GMD Homes

1635 Highland Drive

Proposed updates

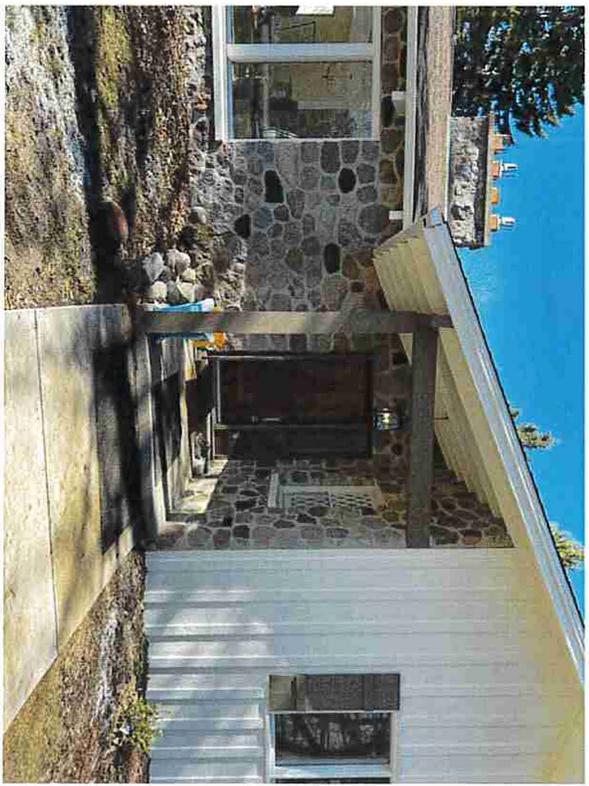
Replace

Replace To match this window

1635 Highland

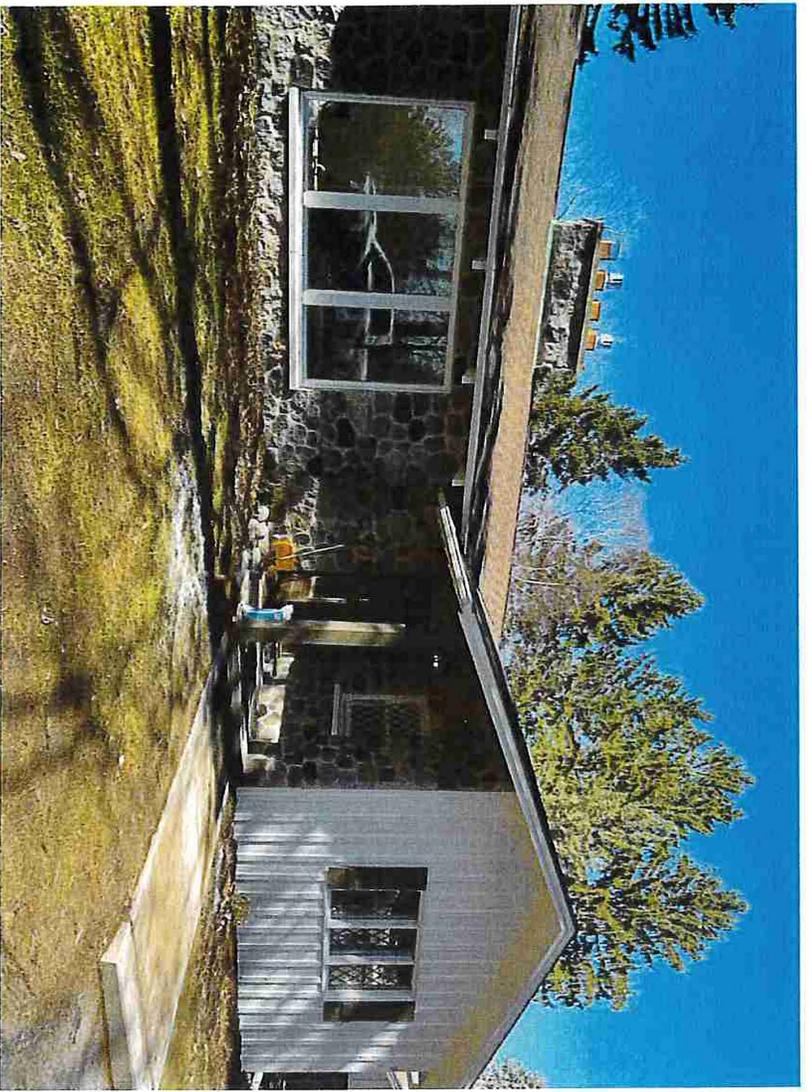
Replace Front Door
with New Glass Door
